LUXURY AT THE LEGENDS

PART OF THE EAST HALF OF SECTION 9. TOWNSHIP 6 NORTH, RANGE 2 WEST, SALT LAKE BASE & MERIDIAN, U.S. SURVEY WEBER COUNTY, UTAH JULY, 2023

Number: 8069-01 Scale: 1"=100'

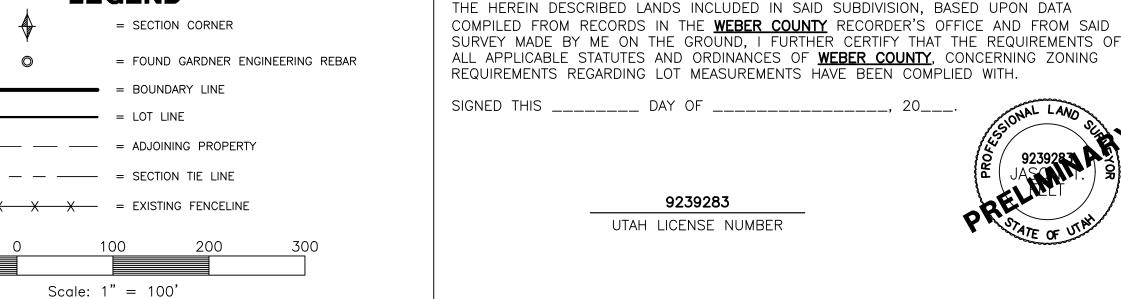
of the applicant....

PROPERTY 106-1-5.10 (g) The location, widths and other

-corner is 0.3' dimensions of proposed public streets, private

access rights-of-way.

future neighborhoods.

Easement for public

ROW 700 North

Street with a 30'

setback.

106-1-5.10 (h) Road connectivity plan showing how

106-1-5.10 (k) Proposed plans or written statements

prepared by a licensed civil engineer regarding the width and type of proposed pavement, location, size,

sewage disposal facilities, proposed water mains and

hydrants and other proposed stormwater drainage

sidewalks, planting and parks and any grading of

facilities and other proposed improvements such as

and type of proposed sanitary sewers or other

future roads can connect to provide circulation to

Street name and

This will remain a

Fire District provide

15-028-0057 HIPWELL, BRENT A & design and safety

WF JILL C HIPWELL reguirements.

private access. The

Owner's dedication language for Weber

County can be found in Section 106-7-1.

106-1-5.10 (c) The individual or company names and addresses

You may remove this

because you plan to

connect to the sewer

district and culinary

signature box

water district.
